# ADDENDUM NO. 3

**October 30, 2023**

**Bid Package No. 2 - LOWELL HIGH SCHOOL RENOVATIONS  
AND NEW SPORTS COMPLEX  
Lowell, IN 46356**

GIBRALTAR DESIGN SHEET  
**A-301-SB**

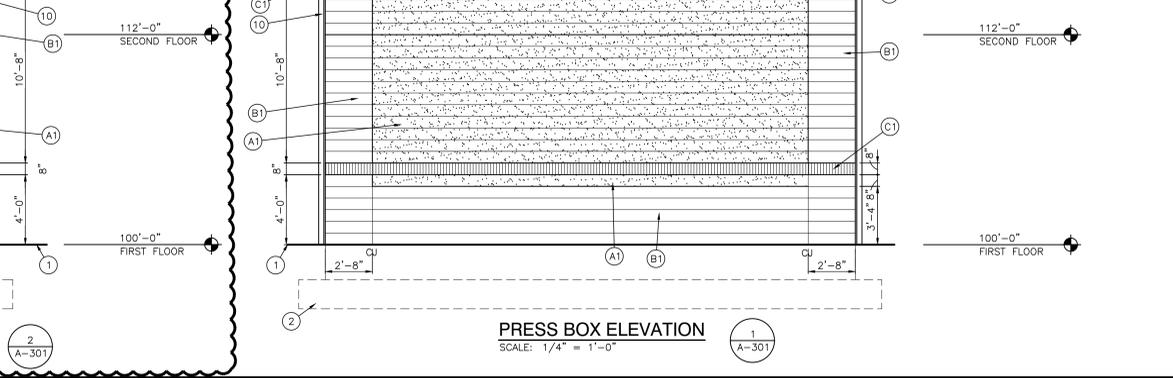
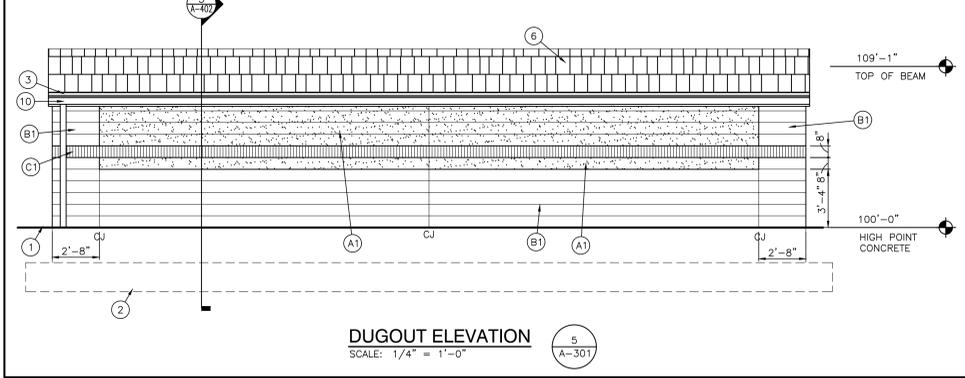
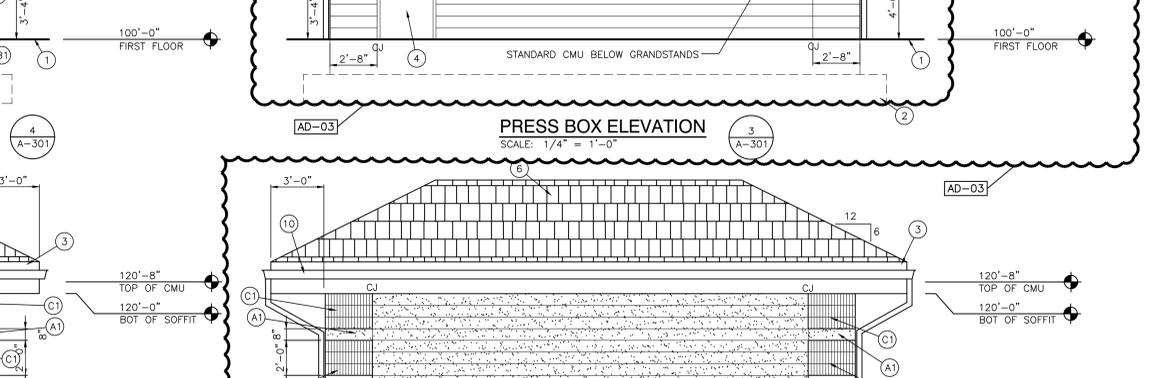
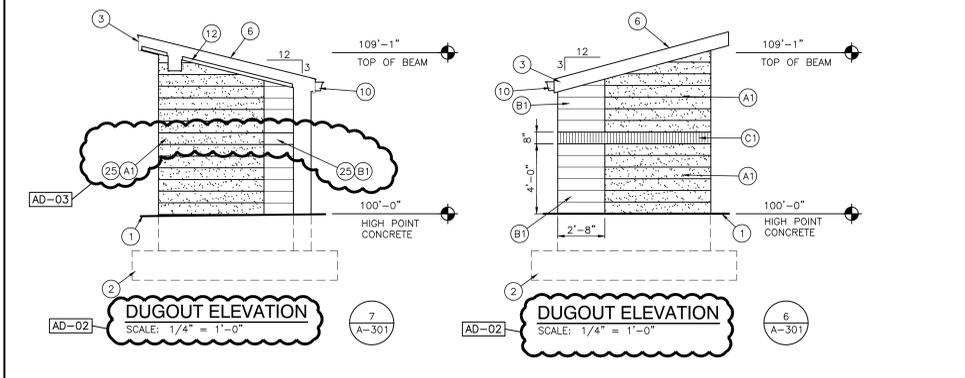
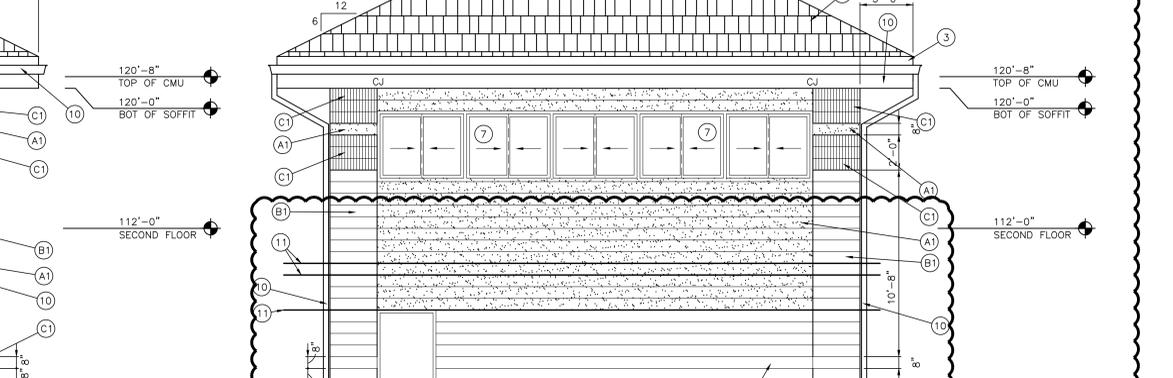
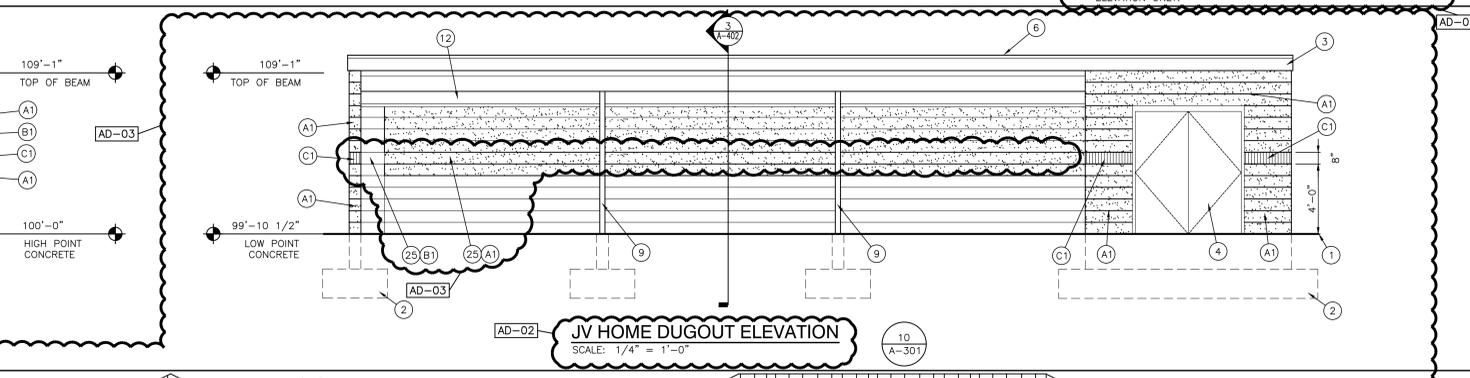
**20. Sheet A-301-SB**

- A. Refer to revised full-size drawing included in this Addendum for the following revisions:
1. Revise Elevation Key Note 11 and add Elevation Key Note 25.
  2. Mirror Elevations 2, 3, 4, and 10.
  3. Revise elevation 3 to show grandstand lines at each grandstand and to show standard CMU under the line of grandstands in lieu of the split face CMU.
    - a. Note. Grandstand height is to be field verified, and no standard CMU shall be visible from on top of the grandstands.
  4. Add notes 25 and associated masonry type to elevations 7,8,10, and 11.

**SOCCER PRESSBOX MECHANICAL PLANS**

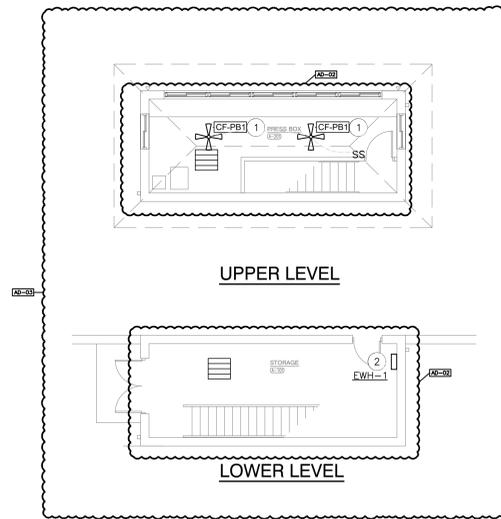
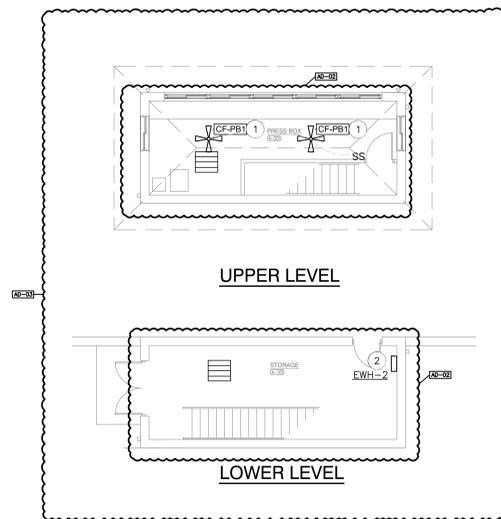
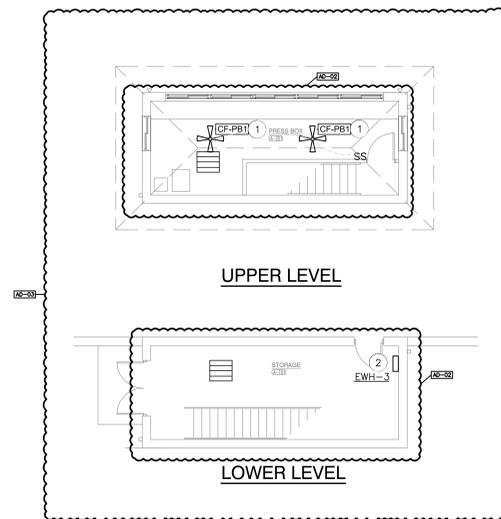
**24. Sheet M-101-SB**

- A. Refer to revised full size drawing included in this Addendum for the following revisions.
1. Press Boxes have been rotated 90° which causes relocation of ceiling fan control switches and storage room wall heaters.

© GIBRALTAR DESIGN SHEET  
**E-102-SB**

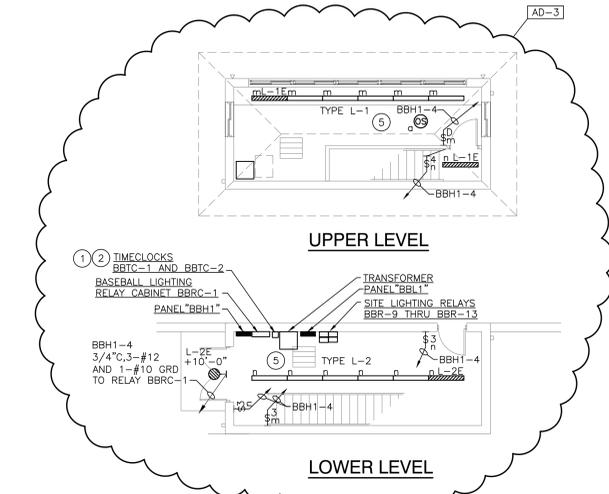
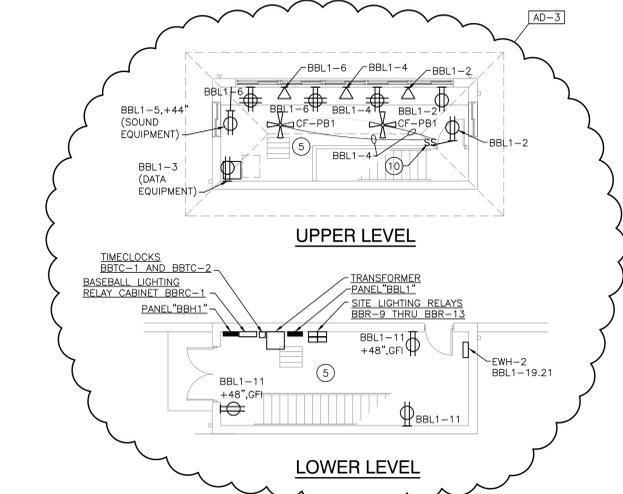
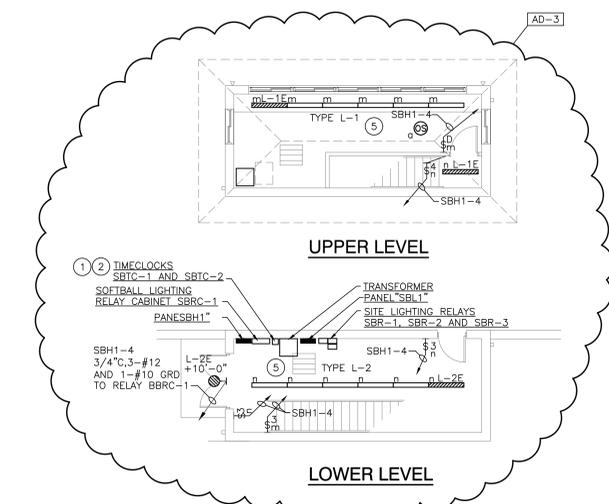
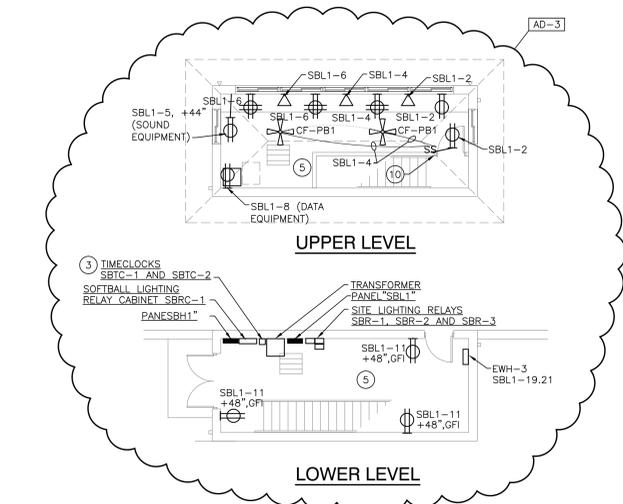
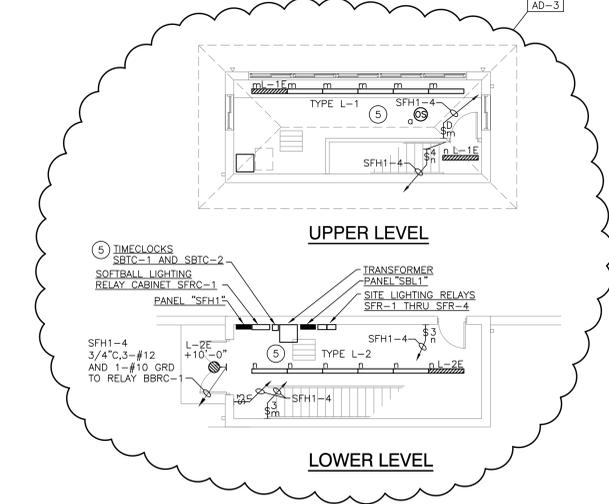
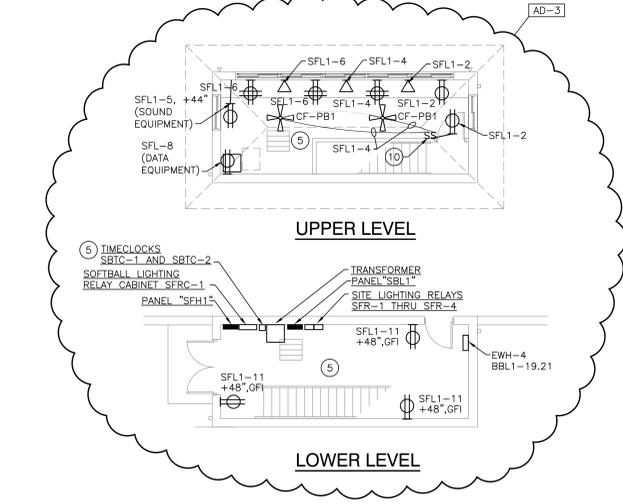
**25. Sheet E-102-SB**

- A. Refer to revised full size drawing included in this Addendum for revisions to the Press Boxes and Ticket Booths.
